# DEVELOPMENT REVIEW BOARD REPORT

MEETING DATE: July 7, 2005 ITEM NO. 25-DR-2005 CASE NUMBER/ **Comerica Branch Bank PROJECT NAME** 7306 E. Shea Boulevard LOCATION Request approval of a site plan and elevations for a full-service banking REQUEST institution. Comerica Bank **DRW** Engineering **OWNER ENGINEER** 602-246-1111 310-725-4192 **DWL** Architects Jeremy Jones APPLICANT/ ARCHITECT/ 602-264-9731 **DWL** Architects COORDINATOR **DESIGNER** 602-264-9731

# Stipulations for Case: Comerica Branch Bank Case 25-DR-2005

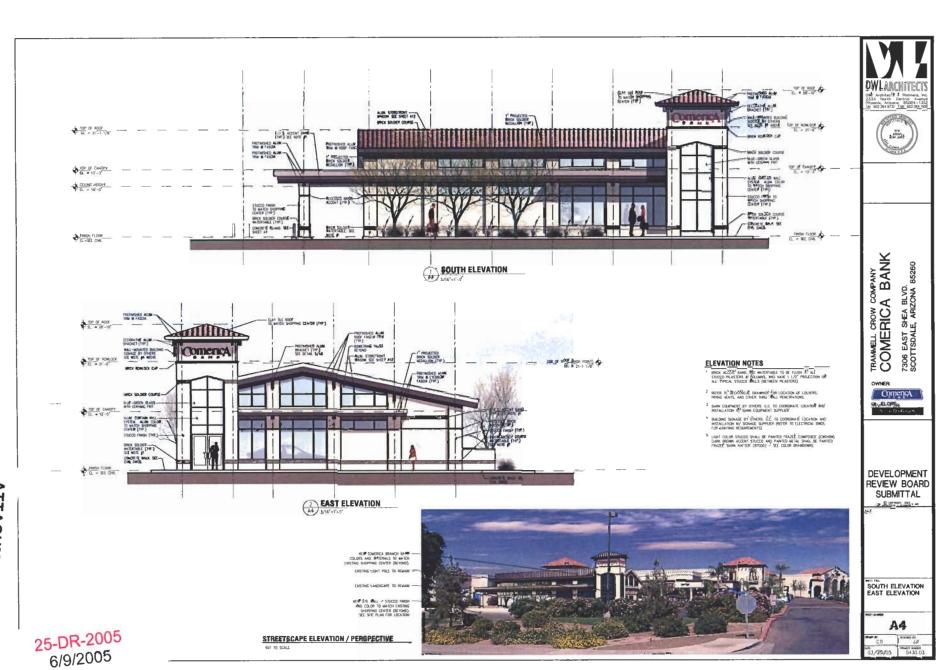
- D. In on site areas of mass planting of shrubs and ground covers, plant spacing must not be more than 7 feet between projected mature canopies.
- E. Fifty percent of trees provided shall be mature as defined in Article III of the Zoning Ordinance. Box size shall be consistent with Arizona Nursery Associations standards for the minimum caliper as required by the Zoning Ordinance.
- F. Contrary to Planting Notes 10 and 13 on the landscape plan, species and locations of plant materials must be approved by the City of Scottsdale in accordance with Article III, Zoning Ordinance.
- G. Contrary to indications in the Plant Legend, turf that is removed or destroyed cannot be restored unless the amounts provided by the entire shopping center are in compliance with limits set by City Code. The maximum permitted amount of water intensive landscape for the entire shopping center is 2,628 SF.
